Access Compliance Report Public Rights-of-Way (Curb Ramps)

Main Street: **OSO_PKWY** Cross Street: **ANTONIO_PKWY** Location: **S**

ADA ID: **RPRK211019123845** Ramp Type: **Type 1 - Perpendicular Diagonal Initial Pass/Fail: Pass** Overall Compliance: **No** Severity Score: **4**

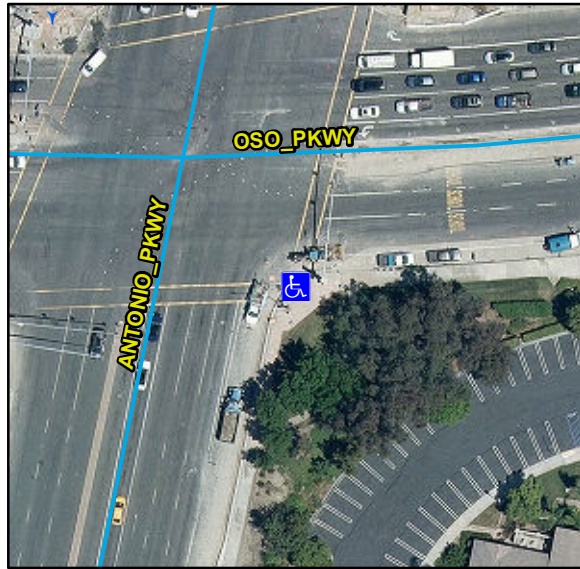
Remove & Replace Landing.

R304.2.1, STD 1115
